Project	IEEE 802.16 Broadband Wireless Access Working Group < http://ieee802.org/16 >		
Title	Contribution on 802.16j (Mobile Multihop Relay) Military Usage Models		
Date Submitted	2006-06-20		
Source(s)	Matthew Sherman, Kevin McNeill BAE SYSTEMS, NES Mail Stop 11B01 164 Totowa Road Wayne, NJ 07474-0975 Voice: +1 973.633.6344 Fax: +1 973.633.6004 E-mail: matthew.sherman@baesystems.com	D. J. Shyy MITRE McLean, VA 22102 Voice: +1-703-983-6515 Fax: +1-703-983-7142 E-mail: djshyy@mitre.org	Seth Spoenlein US Army - CERDEC Systems Engineering Space & Terrestrial Communications Directorate Ft. Monmouth, N J Voice: (732) 427-0035 E-mail: Seth.Spoenlein@us.army.mil
Re:	Submitted in response to motion passed in 802.16j TG meeting in Tel Aviv to from Ad Hoc Group tasked with producing a harmonized contribution on 802.16j Usage Models.		
Abstract	This contribution describes Military requirements for the 802.16j usage models. The changes described are relative to the document titled C80216j%2d06_UMAHtemp_r4[1].doc. Desired changes are indicated as <u>underlined</u> or crossed-out text.

802.16j (Mobile Multihop Relay) Usage Models

Figure 4 Topological Constructs

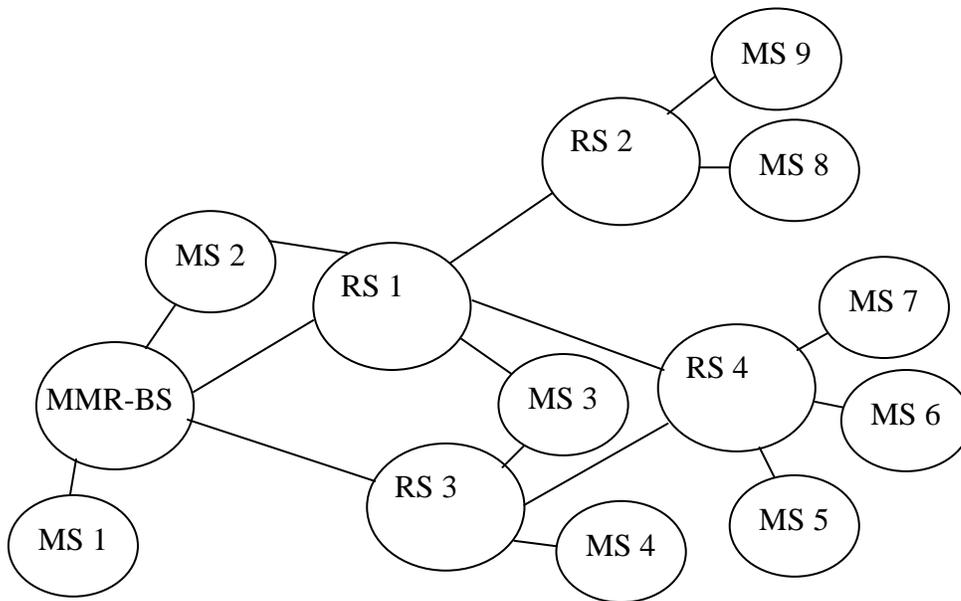
The following figure illustrates the types of topological constructs that are possible in the usage models described in section 3. In the figure RS refers to either a fixed, nomadic, or mobile RS. For military scenarios, two or more mobile RS nodes may need to communicate to each other while moving.

In most of the usage models described in section 3 the topology will allow multiple RSs and the MMR-BS to be within communication range and therefore potentially communicate with one another. In these topologies multiple routes between the MMR-BS and an MS will be possible. An example of multiple routes is shown in

Figure 4 where there are two routes between the MMR-BS and MSs 5, 6, and 7, served by RS4 (one through RS 1 and one through RS3). ~~It should be noted that even when multiple routes are enabled between the RSs, the overall topology is still tree-like because all data communications are between the MMR-BS and MSs and this usage does not violate the scope as defined in the 802.16j PAR.~~ Another example of multiple routes between the MMR-BS and MS is show in Figure 4 where MS2 can be accessed directly from the MMR-BS and also from RS1.
